ONE CHASE MANHATTAN PLAZA  
NEW YORK, N. Y. 10005WASHINGTON TELEPHONE:  
202 FEDERAL 8-0111ARVIN E. UPTON  
EUGENE B. THOMAS, JR.  
LEONARD M. TROSTEN  
WASHINGTON PARTNERSAngus Macbeth, Esq.  
Natural Resources Defense  
Council, Inc.  
36 West 44th Street  
New York, New York 10036Re: Consolidated Edison Company  
of New York, Inc.  
Indian Point Unit No. 2  
AEC Docket No. 50-247

Responses to Questions Supplied by Hudson River Fishermen's  
Association on October 22, 1971.

FIGURE 1  
AVERAGE DAY - AUGUST 1971

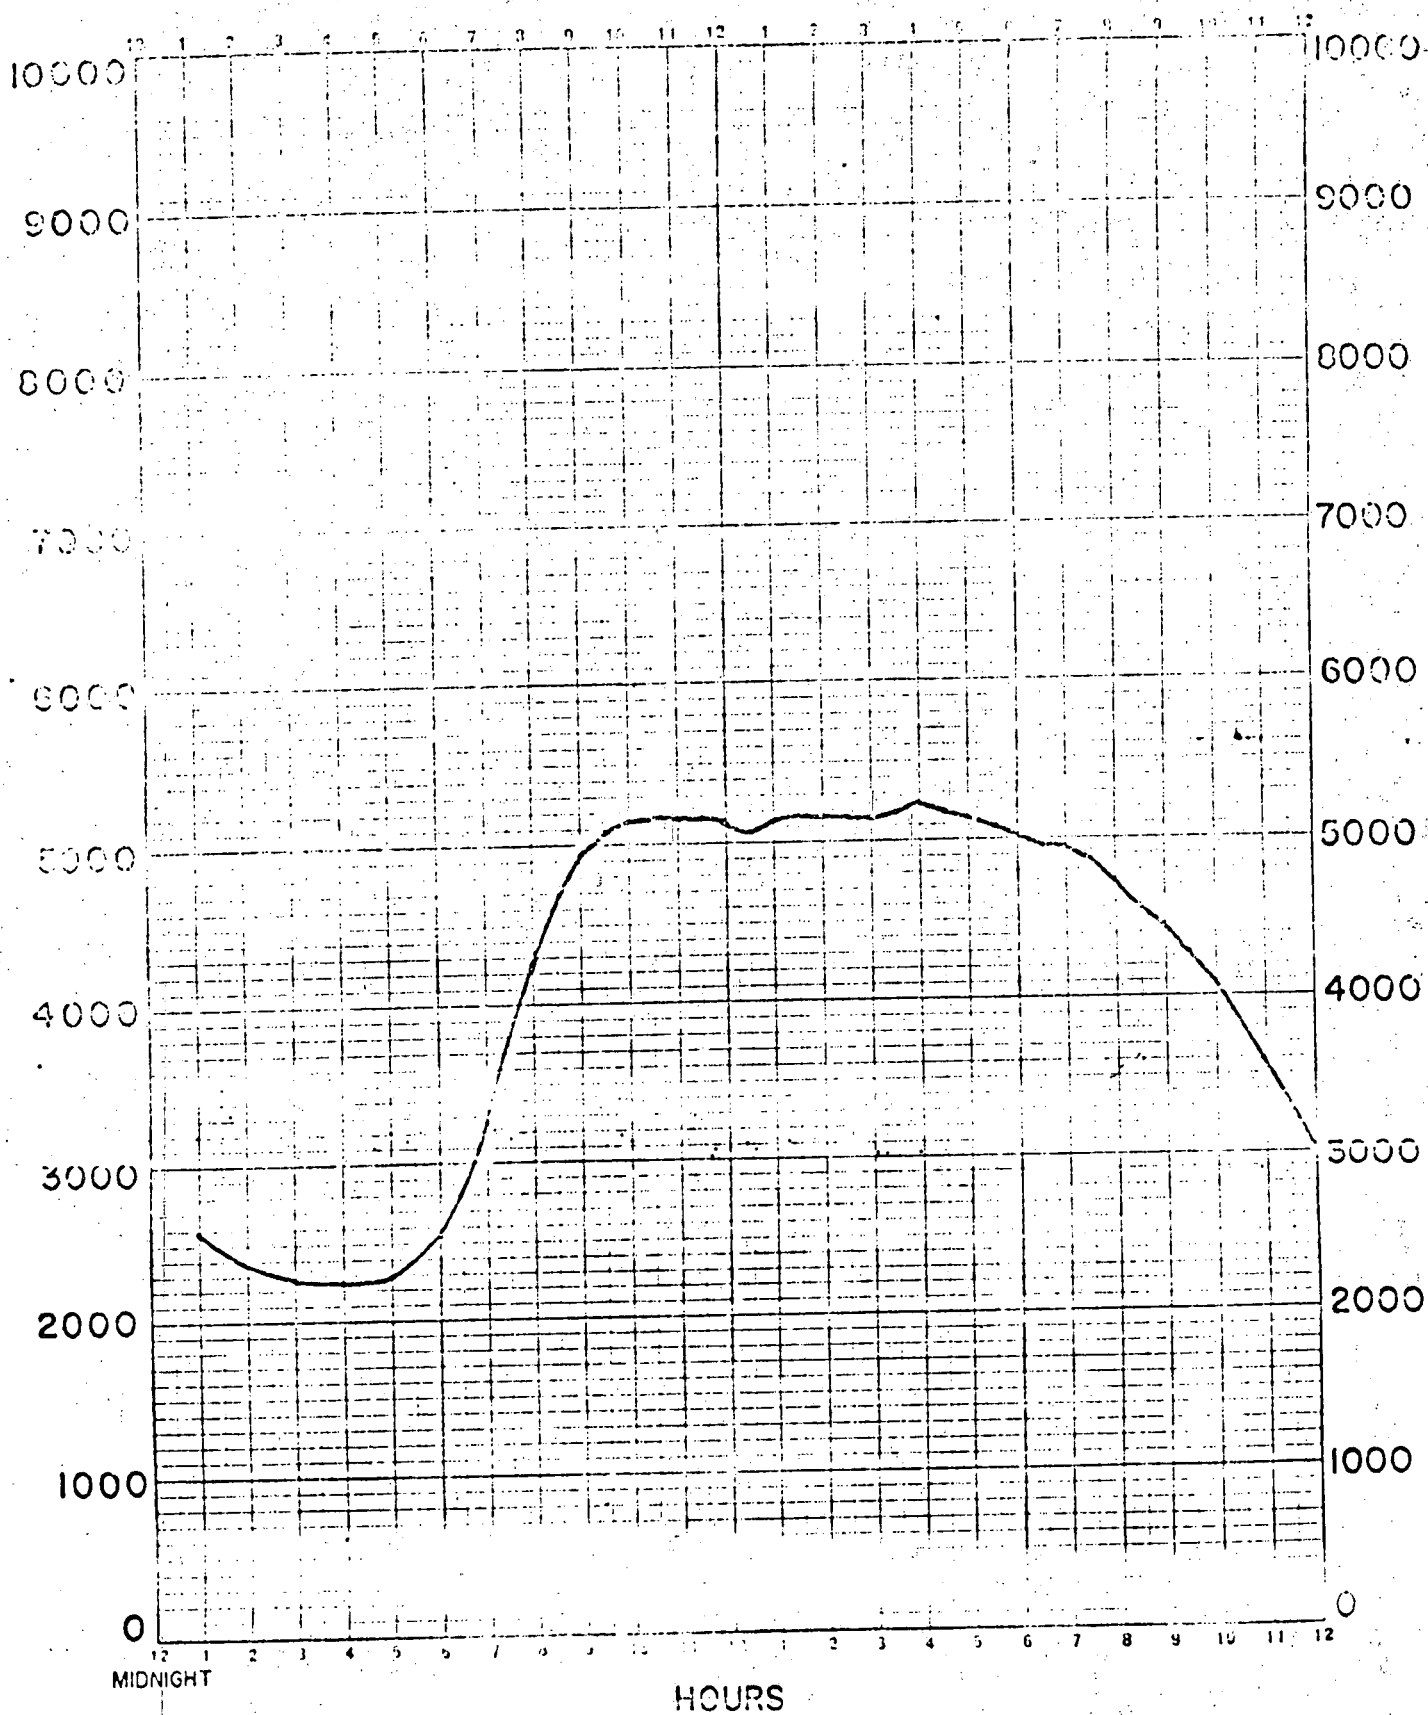
3. What are the present power demands in the entire Consolidated Edison system, on an hour by hour basis, during the course of an average day in a) January b) April c) August d) October? A graphical presentation of these data showing twenty-four (24) hour continuous demands would be most useful.

The attached graphs, Figures 3-1, 3-2, 3-3 and 3-4, indicate on an hour by hour basis the loads on an average day in October 1970, January, 1971, April, 1971 and August, 1971, respectively.
